**Re: Response Letter – Transportation Study Addendum
117 Forest Avenue and 175 Catharine Street South
City of Hamilton
Our Project No. NT-16-103**

SUBJECT: 117 Forest Avenue and 175 Catharine Street South, Hamilton (Ward 2)
ZAC-23-019

Figure 1 – Short-Term and Long-Term Bicycle Parking Spaces

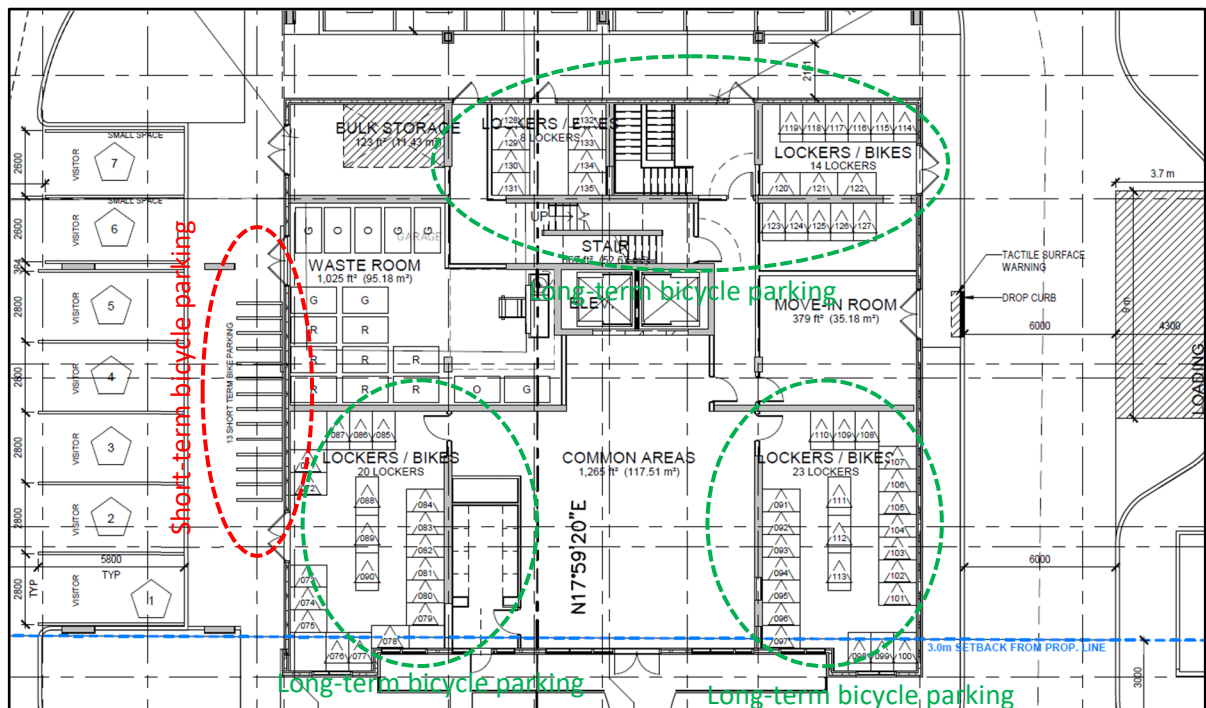
- Transportation Planning requires short-term and long-term bicycle parking to be provided as per the requirements of the City of Hamilton Comprehensive Zoning By-law 05-200, Section 5: Parking. All short-term and long-term bicycle parking shall be clearly indicated, illustrated and the total number of spaces shall be numbered on the site plan accordingly.

Response: Noted. This comment has been addressed in Table 1 below. All short-term and long-term bicycle parking spaces are indicated on the site plan, as illustrated in Figure 1 and Appendix B.

Figure 3 – Catharine Street South and Young Street

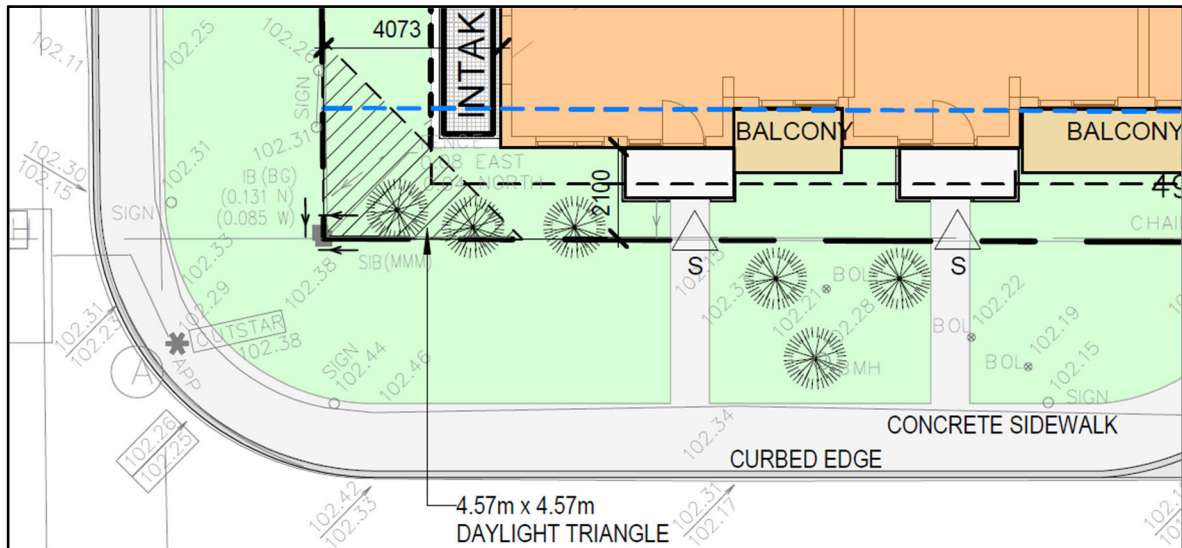
8. Catharine Street South & Young Street are both Local Roads. The Applicant is to dedicate a 4.57 metres x 4.57 metres Daylighting Triangle to the right-of-way, as per the Council Approved Urban Official Plan: Chapter C - City Wide Systems and Designations 4.5 Road Network Functional Classification; Daylighting Triangles 4.5.7.

Response: It should be noted that this requirement is not possible as both the existing transformer and building bearing wall will remain and will not be altered as part of the site redevelopment. Please see **Figure 3** for more information. Therefore, the required daylight triangle cannot be provided and it will be operating similar to the existing condition.

Figure 4 – Daylight Triangle Requirements for Proposed Driveways

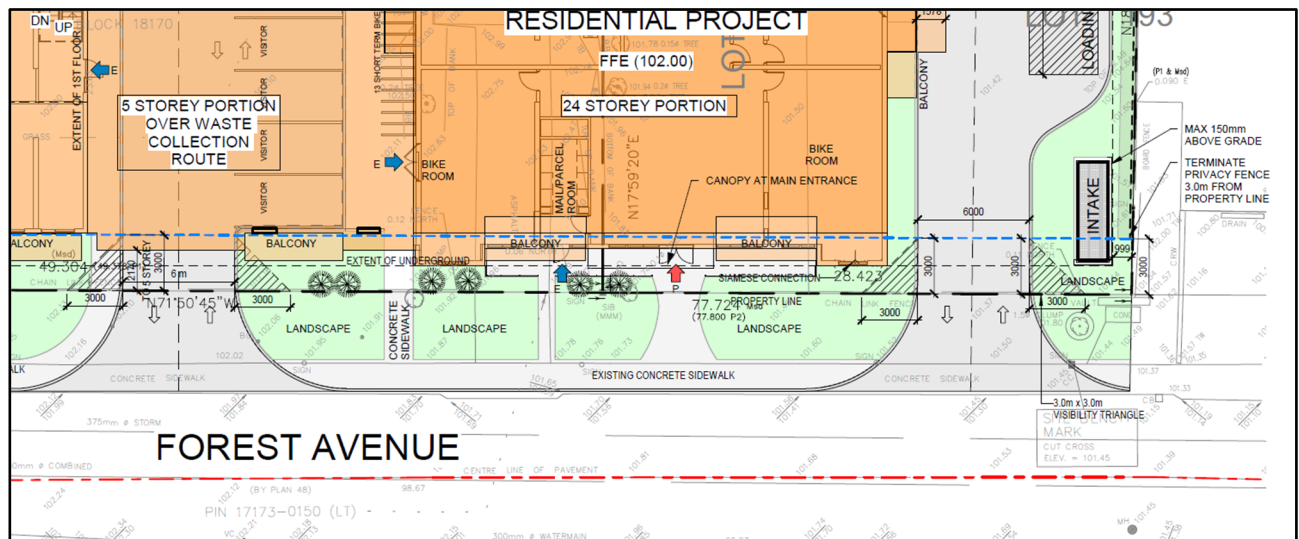
12. A minimum of 3.0 metres x 3.0 metres visibility triangles should be provided for each driveway access. They must be illustrated, dimensioned and identified on the site plan. Visibility triangles are between the driveway limits and the ultimate property line (right-of-way limit) and no object or mature vegetation can exceed a height of 0.6 metres above the corresponding perpendicular centreline elevation of the adjacent street.

Notwithstanding and without setting precedent, Transportation Planning will accept reduced visibility triangle dimensions however the Applicant shall consider visibility restrictions when designing the at-grade features of the subject lands in the areas where a typical 3.0 metre x 3.0 metre visibility triangle would be located, as illustrated in Figure 2.

Response: Noted. This requirement has been addressed in the revised site plan (Appendix B) and Figure 4 below.

Figure 5 – Convex Mirrors and Warning Signage

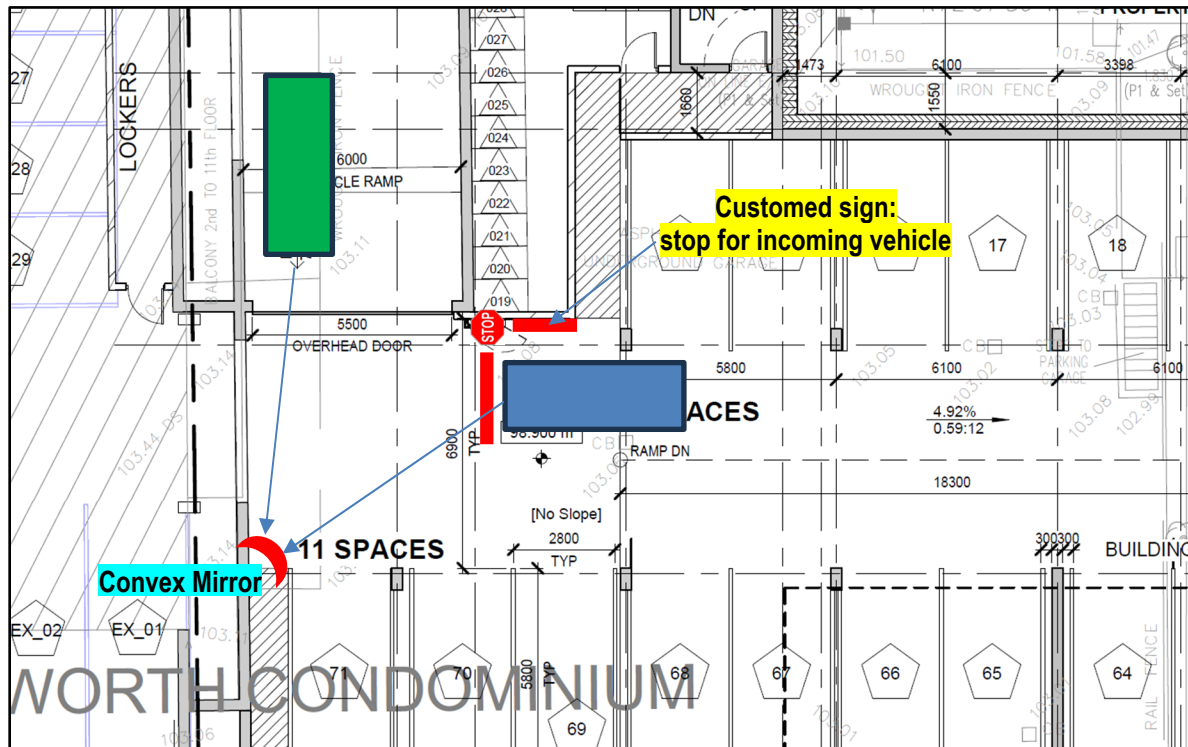
Transportation Planning recommends mirrors or warning systems to be implemented within this area to assist in facilitating the two-way movement of vehicles entering/exiting the underground parking area.

Figure 2: Subject Submission Overhead Door Width

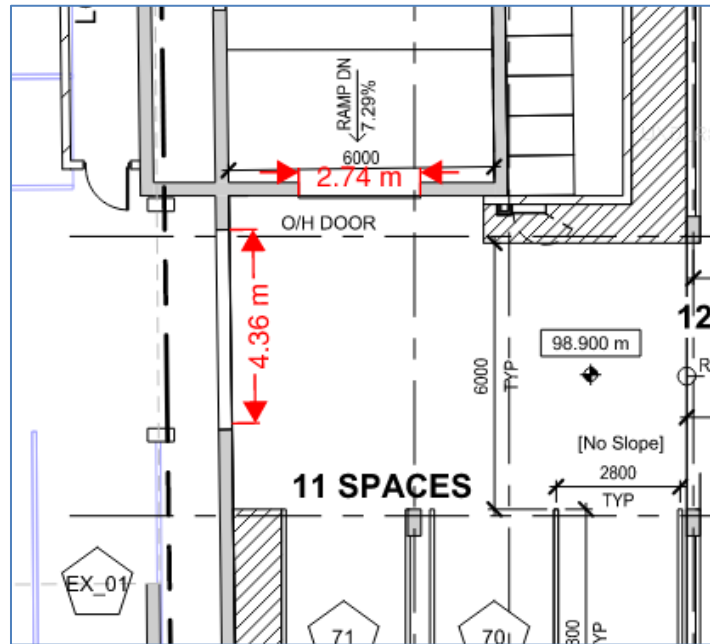
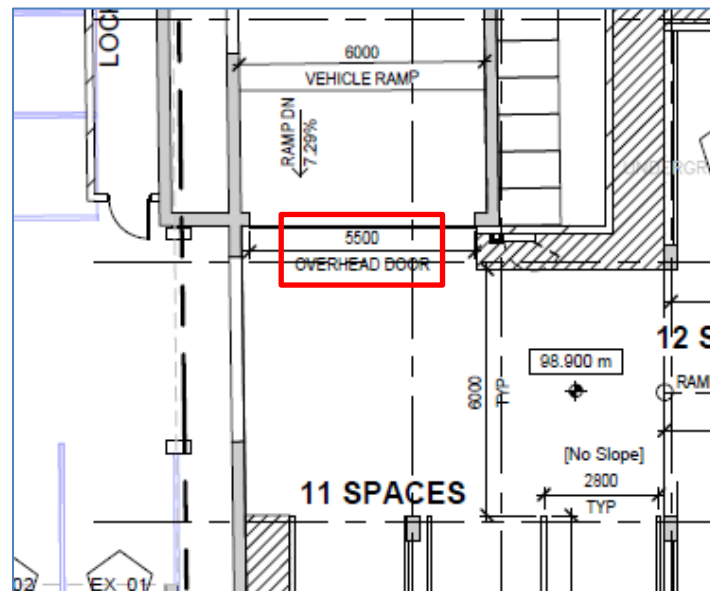
11. The proposed 'Covered Ramp to Underground Concrete Terrace' is too narrow to allow for two-way movements based on approximate dimensions measured from the most recent site plan submitted as illustrated in **Figure 2**.

Transportation Planning indicates that interim discussions between the Applicant and City staff have noted a discrepancy in the overhead door width. A corrected interim submission site plan illustrated in **Figure 3** indicates the overhead door width shall be 5.5 metres. Typically, a minimum of 6.0 metres is required to facilitate two-way movements internal to private property. Notwithstanding and without setting precedent, Transportation Planning will accept the proposed overhead door width of 5.5 metres, as the overall number of parking stalls is low and there is a long approach throat length extending from Young Street that will allow for vehicles to queue while waiting for opposing vehicles to maneuver in/out of the underground parking area.

Transportation Planning recommends mirrors or warning systems to be implemented within this area to assist in facilitating the two-way movement of vehicles entering/exiting the underground parking area.

Response: Noted and no further action is required for this comment.
